ADDENDUM No. 1

PROJECT MANAGEMENT - PUBLIC SERVICES - CITY OF ANN ARBOR  
GEDES AVENUE IMPROVEMENTS  
PROJECT DETAILS  
INFILTRATION DETAILS

PROJECT MANAGEMENT - PUBLIC SERVICES - CITY OF ANN ARBOR  
GEDDES AVENUE IMPROVEMENTS  
GEDDES AVENUE TYPICAL SECTIONS  
P.O.B. TO 23+75

STORM SEWER PLAN AND PROFILE

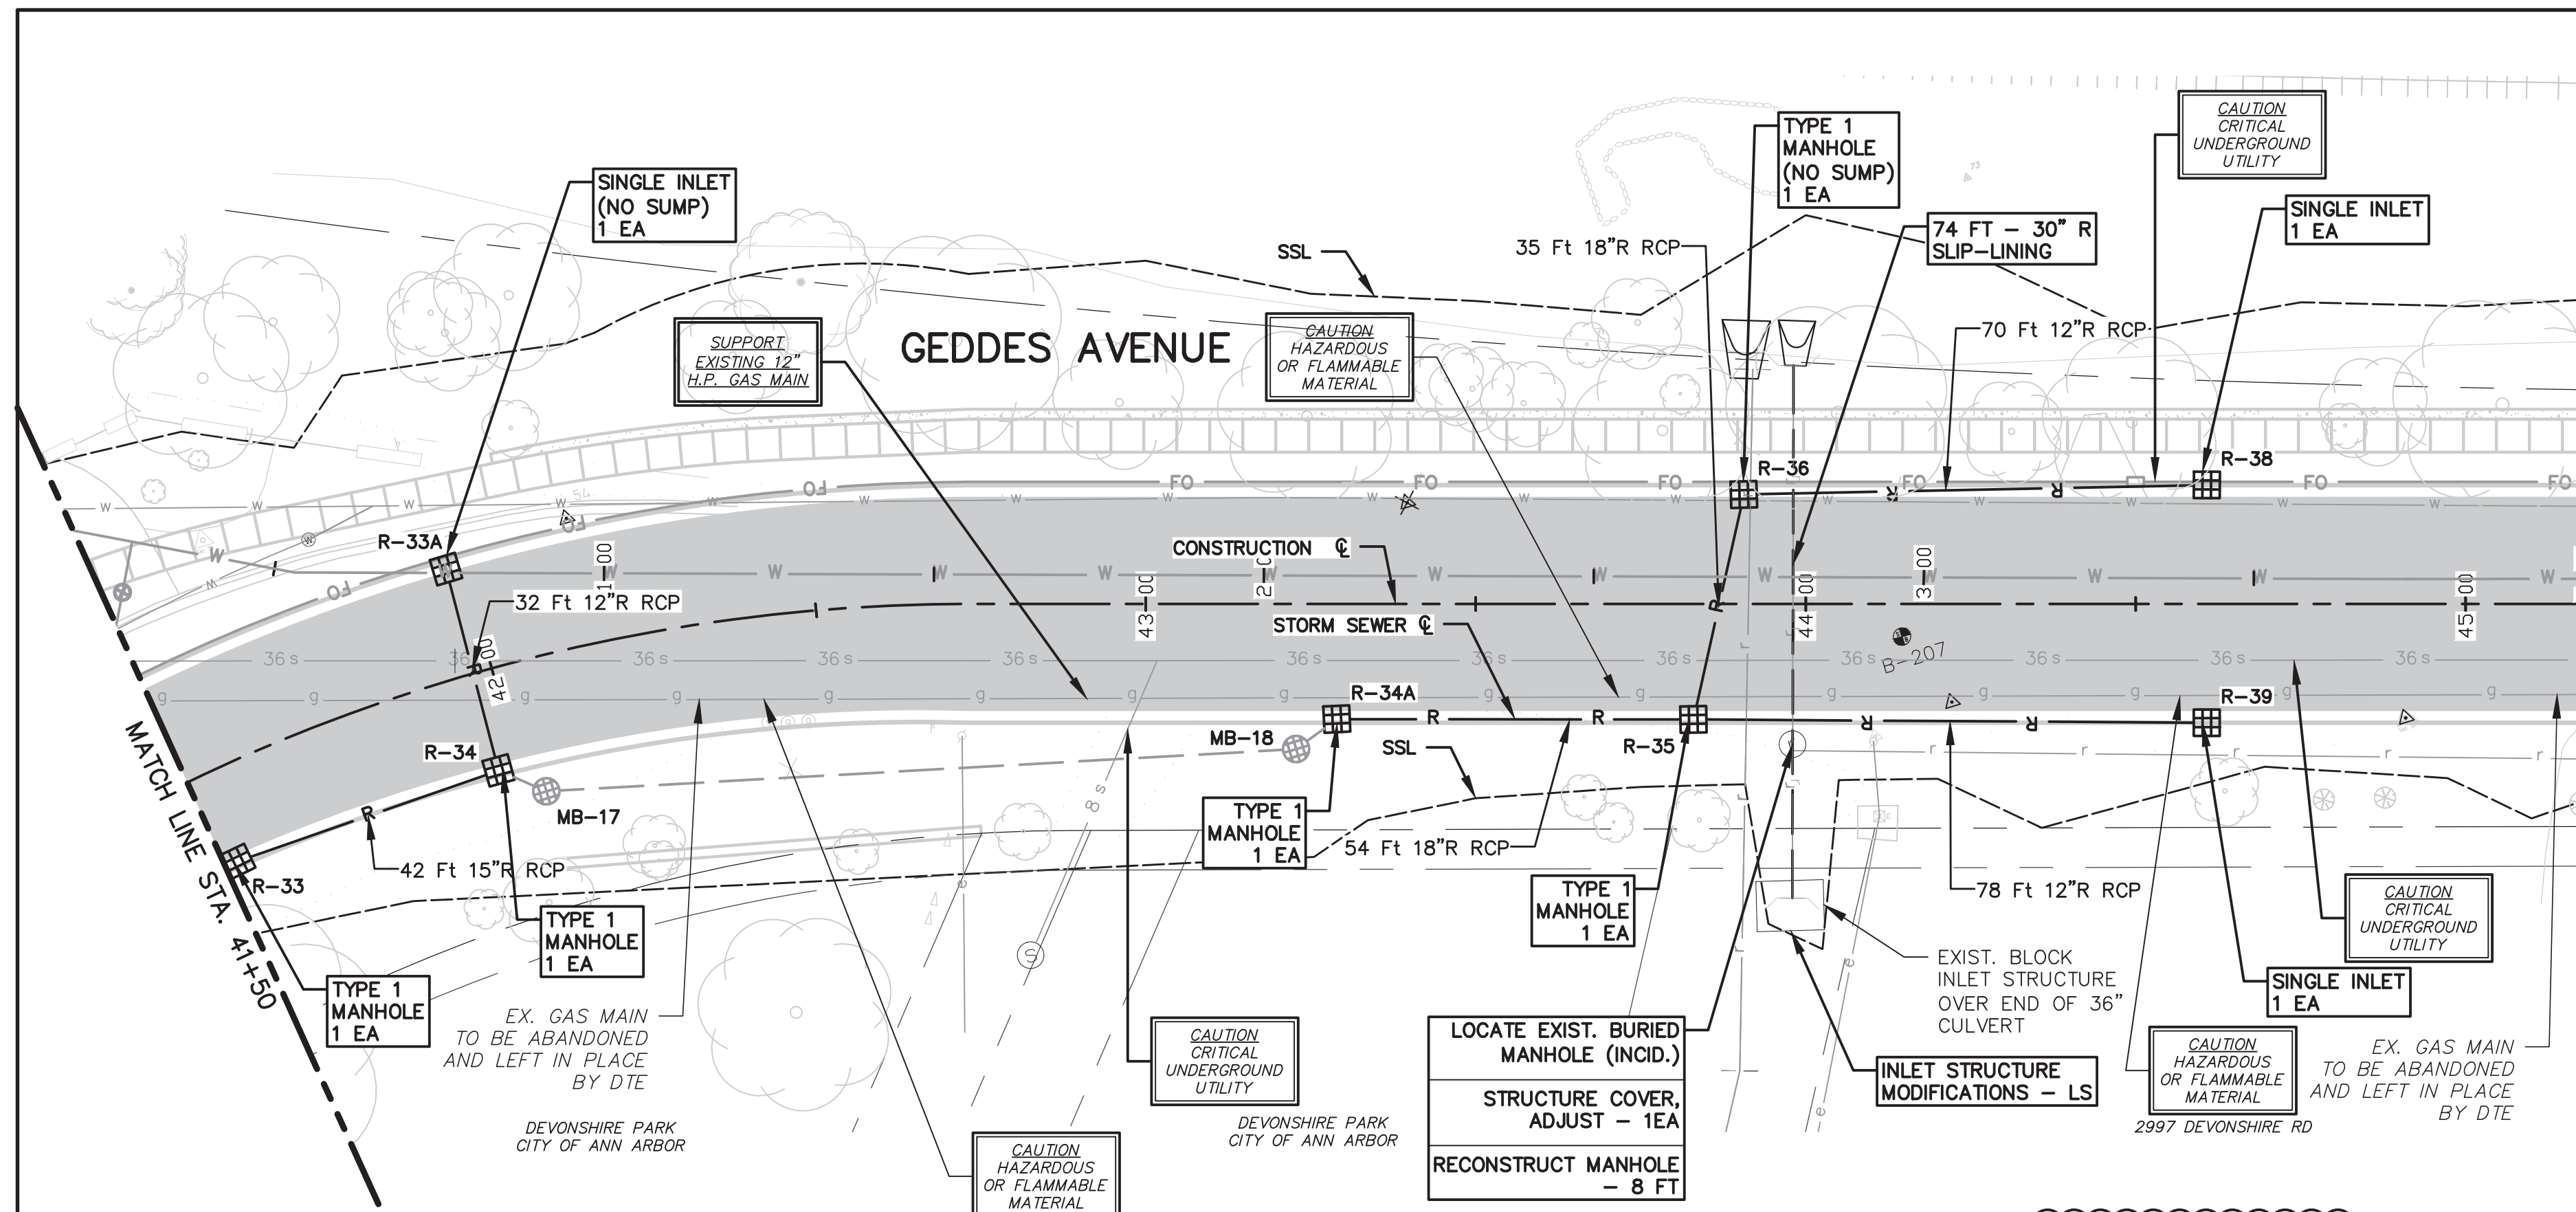
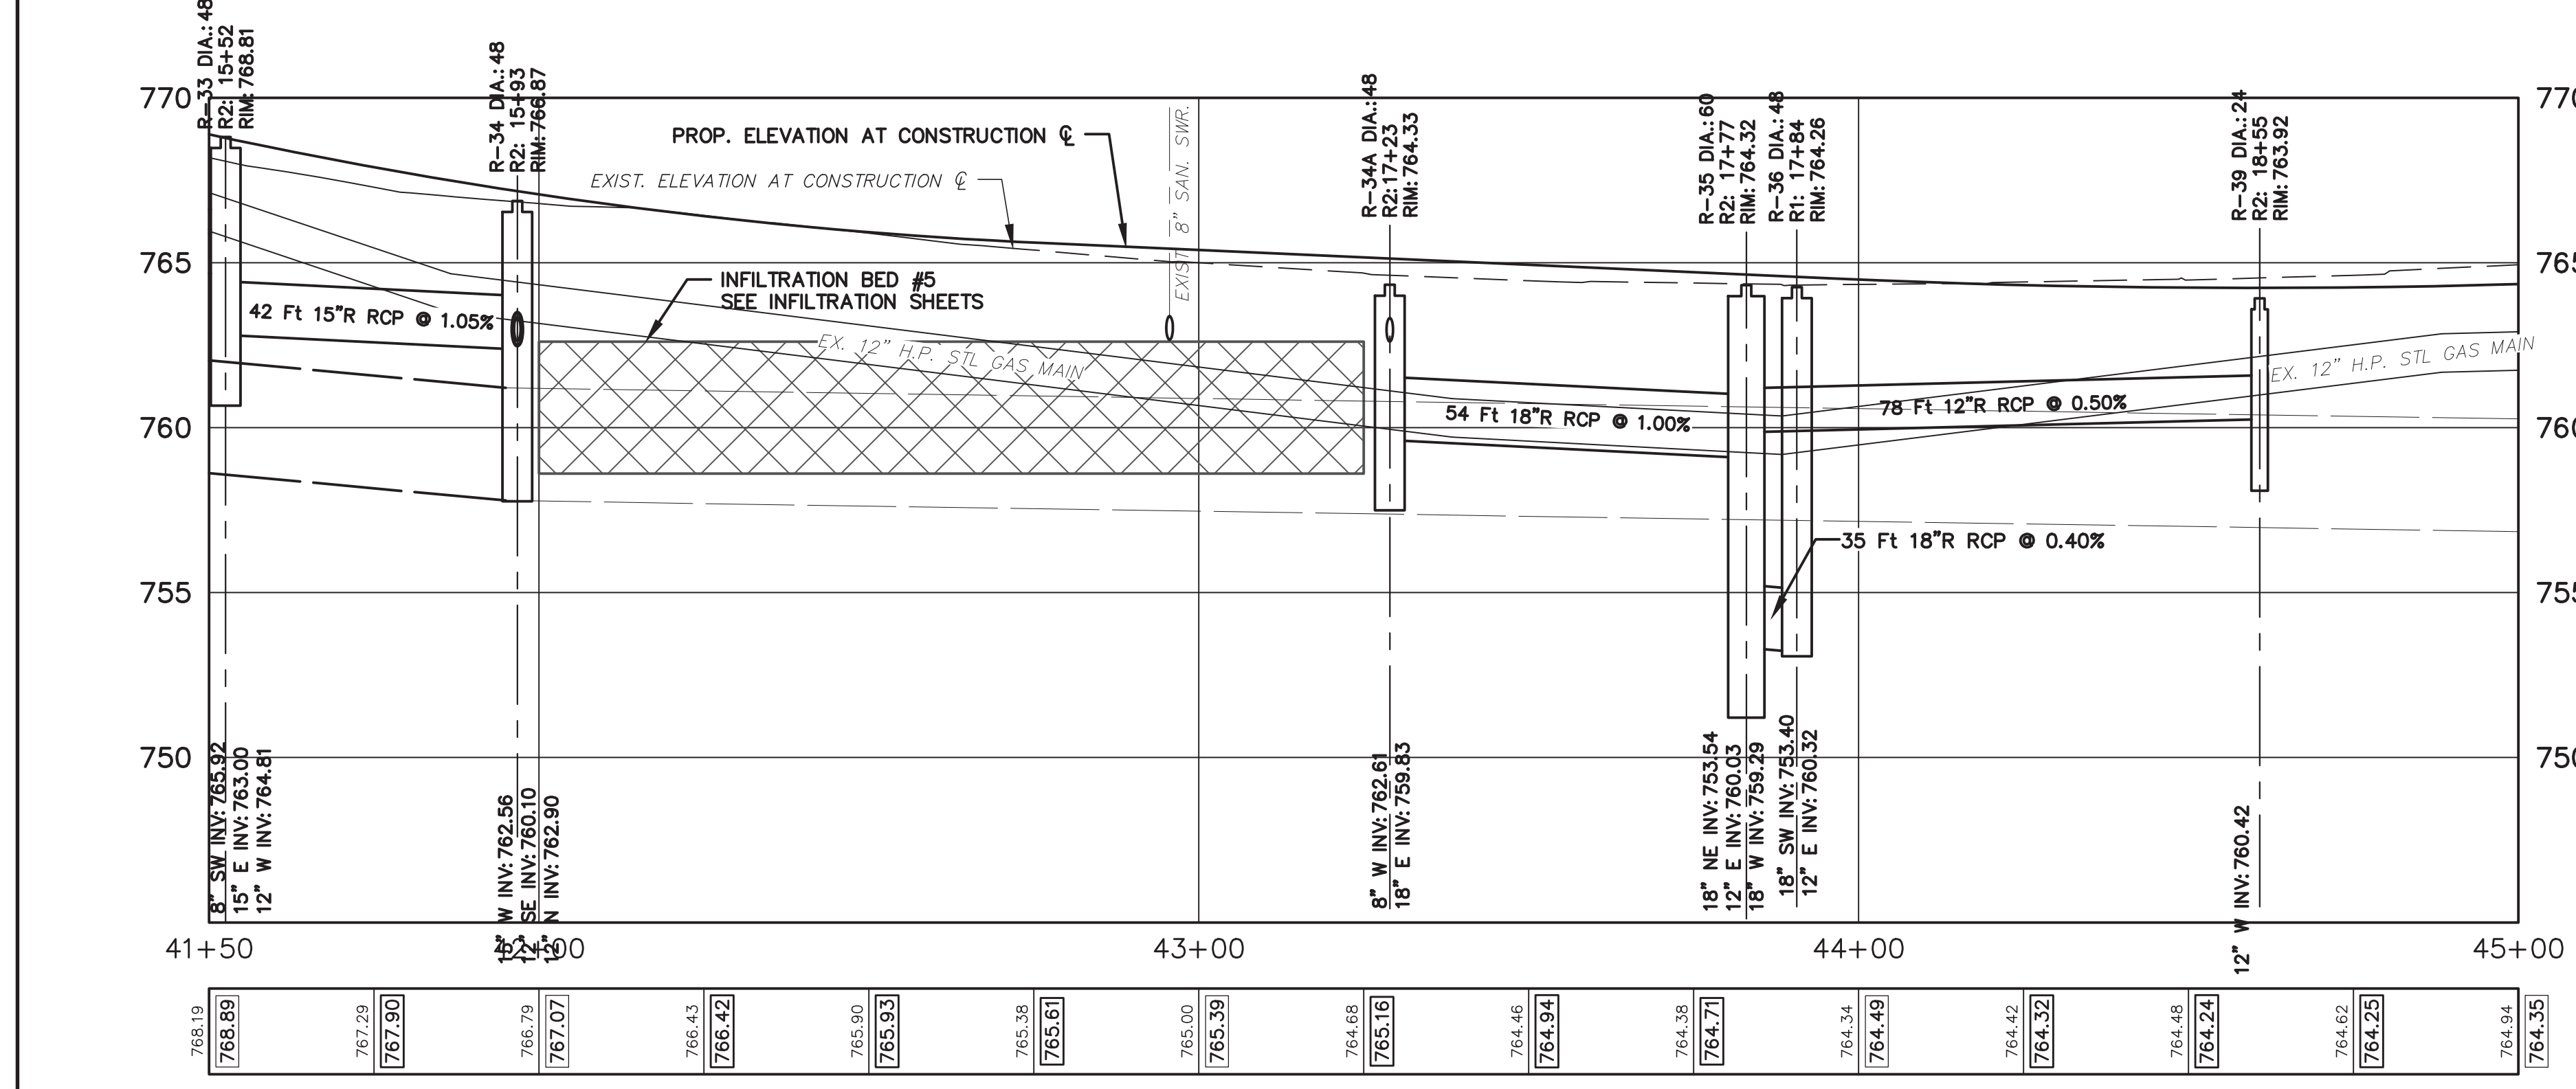
ALL DEPTH INFORMATION HAS BEEN UPDATED IN THE STORM SEWER STRUCTURE TABLE. STRUCTURES NOT REQUIRING A SUMP HAVE BEEN IDENTIFIED. THE RIM FOR R-33A HAS BEEN UPDATED.
